INSPECTION AND REPLACEMENT OF NOSE GEAR DRAG LINKS

Lancair IV, IV-P, IV-PT, and Legacy

SB078-0722

Figure 3

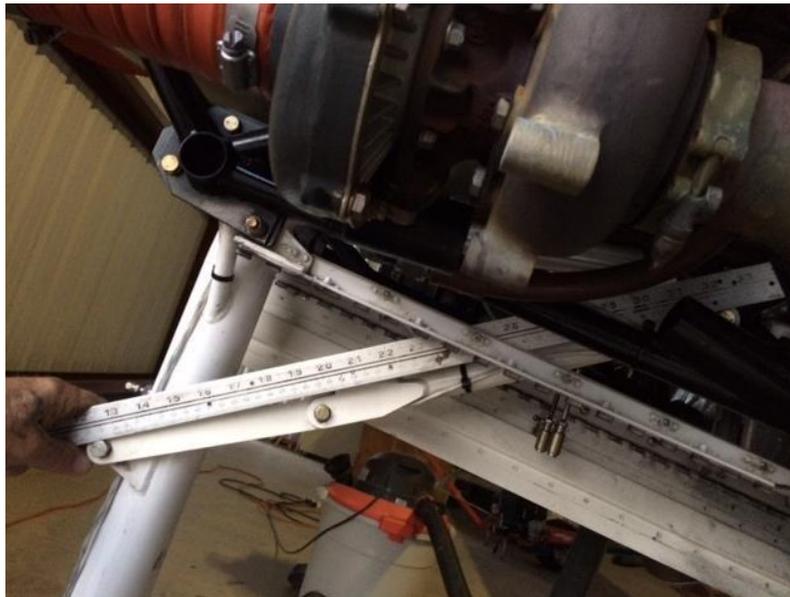
- 6.2.1** Aircraft equipped with the original steel-on-steel pivots (without the bronze bushings) will have a bolt with a castle nut secured with a cotter pin. Aircraft equipped with the improved pivots will have a tension bolts and locking nut.
- 6.2.1.1** Using a straightedge, check that the drag links are over-center shown in Figure 3. There is no “over-center distance” specified, but a range from $\frac{1}{4}$ ” to $\frac{1}{2}$ ” as measured from the centerline of the pivot bolt joining the upper and lower links is ideal.

Figure 4

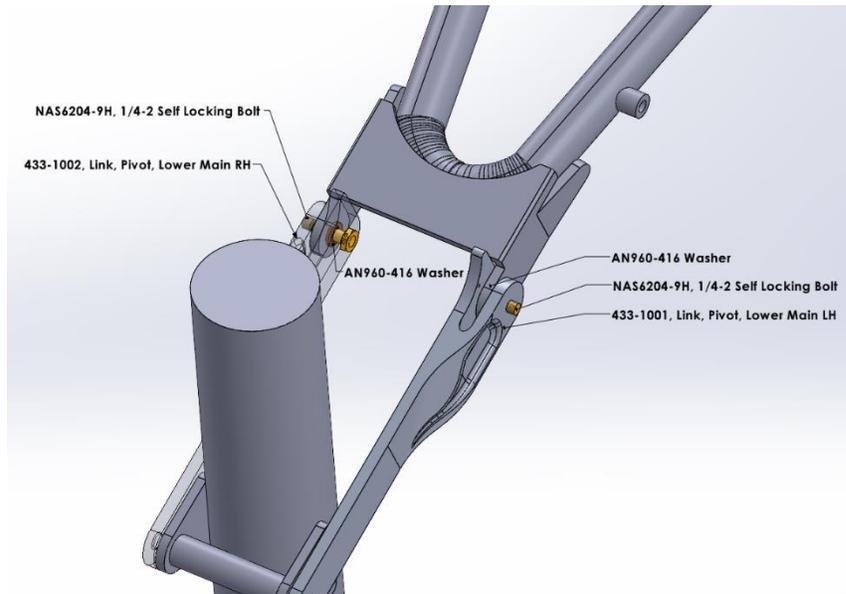
- 7.2** Procedure (See Figure 2 and 4):
- 7.2.1** Lubricate lightly and install the new 433-1001 Lower Drag Link LH and 433-1002 Lower Drag Link RH.
- 7.2.2** Install the new lower links to the over center link using NEW NAS6204-7H Self Locking Bolts (head on inside of the assembly, threads going outboard) and AN960-416 Washers.

- NOTE:** The AN960-416 washers should be installed between the upper and lower drag links, on the inside faces between the links to allow free movement of the linkage through its required range of travel. DO NOT install them under the head of the new self-locking bolts.

- 7.2.3** Before attaching the 433-1001 & 433-1002 Lower Drag Links to the nose strut, torque the above NAS6204-7H bolts enough to cause a slight resistance and ensure each of lower links pivots freely on the upper link through the full range of movement required during gear retraction.

- Do not continue re-assembly until this condition is satisfied for both lower links. This may require removal of paint from the mating surfaces.**
- If the full range of motion is achieved, safety wire both NAS6201-7H Self Locking Bolts to the corresponding Lower Drag Link. A small hole for safety wire can be found on the curvature of the stop.

NOTE: The Upper Over center Link Assembly has been upgraded to a stronger part by SB074-0111. If you have not complied with this service bulletin, it is recommended that SB074-0111 be incorporated at this time.

SB074-0111 applies to both over center link tab configurations shown in Fig. 4, SB074-0111 also addresses the installation of a Hydraulic actuator end with a spherical bearing. For further details on the inspection please refer to SB074-0111.
